CREG analysis of 2nd amendment of Core ID CCM

23 May 2023

2nd Amendment of Core ID CCM

Core proposal (3) Recomputation actual

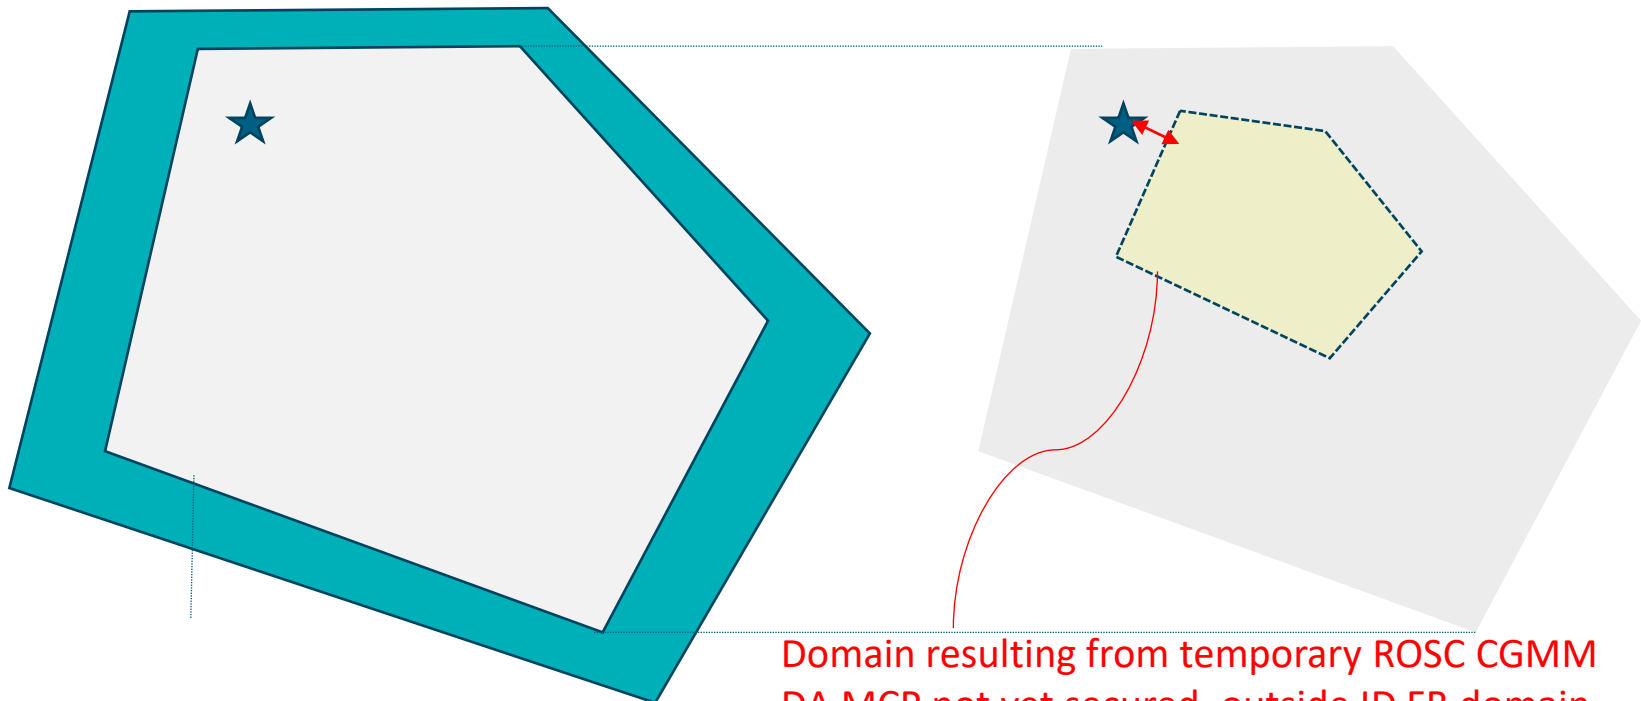
Using ROSC CGM Interim*

Domain resulting from temporary ROSC CGMM
DA MCP not yet secured, outside ID FB domain
→ °Zero positive ID ATC
→ “°Negative ID ATC”

*Interim ROSC CGM does not contain all costly and non-costly RA to secure DA market outcome, congestions on CNECs and non-CNECs may still exist (°negative RAM) 10

Illustration CACM compliance?

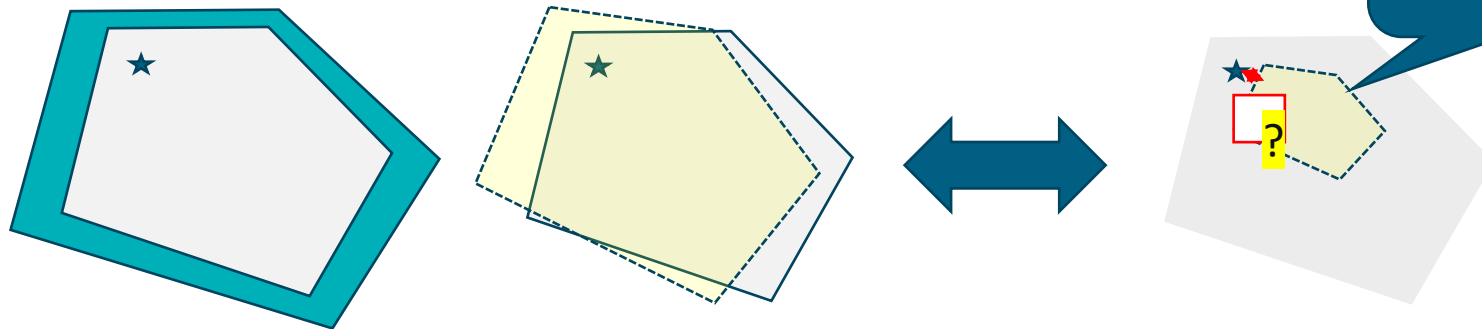
Remedial actions taken into account in the intraday capacity calculation are the same as in day-ahead capacity calculation, taking into account their availabilities (CACM Art.25(6))
 +
 Rules for avoiding undue discrimination (CACM Art.29(b)(iv) / CEP Article 16(8))
 +
 Optimisation of cross-zonal capacity using available RA taken into account in capacity calculation (CACM Art.29(4))

Capacities based on proposed and agreed RA in interim ROSC CGM = **subset of available RA!**
 +
 No provisions on 70% for the market
 +
 No optimisation of cross-zonal capacity

Impact of the foreseen ROSC-IDCC alignment

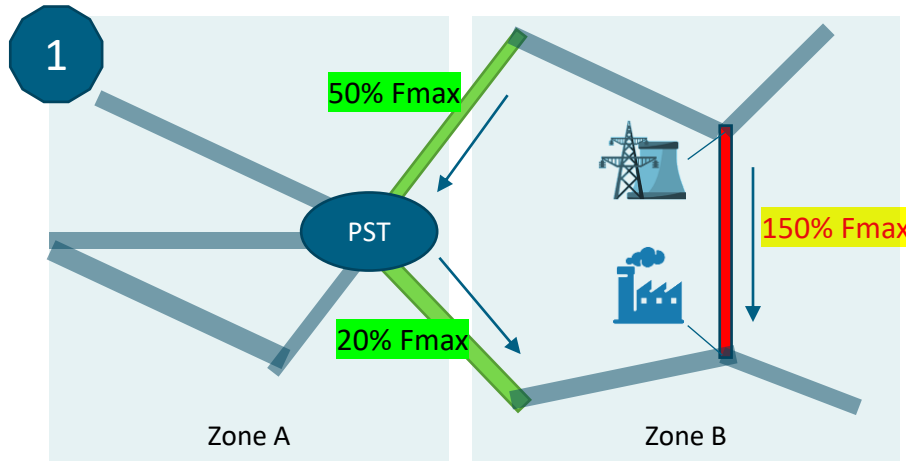
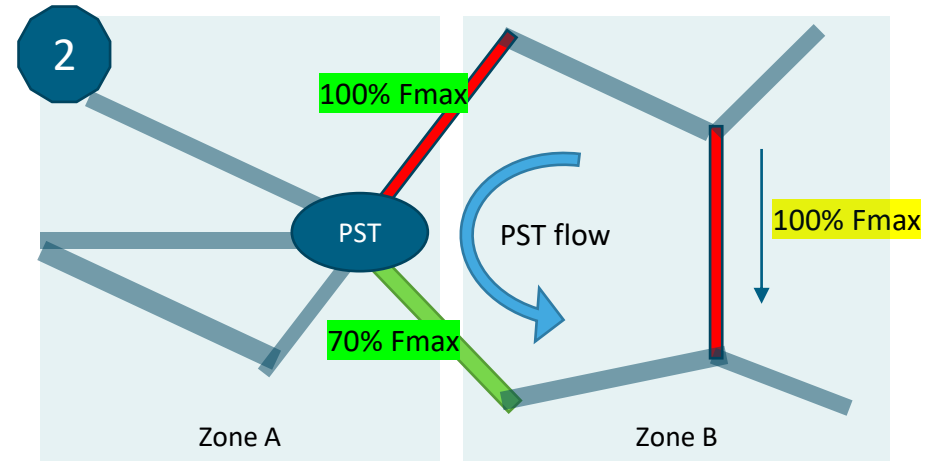
Illustration with start of ROSC process with only one single congestion on an internal XNE after DA market clearing

Result DA market clearing
Congestion on internal XNE (non-CNEC)
Still capacity available on CNECs

If virtual margins are not removed, providing
DA left-overs on CNECs is at least CEP
compliant

Result ROSC Process (simplified illustration!)
Use of PSTs is preferred to the use of internal
redispatching, thereby “consuming” capacity on
CNECs

Using this ROSC output for extracting intraday
capacities is not CEP compliant neither CACM
compliant
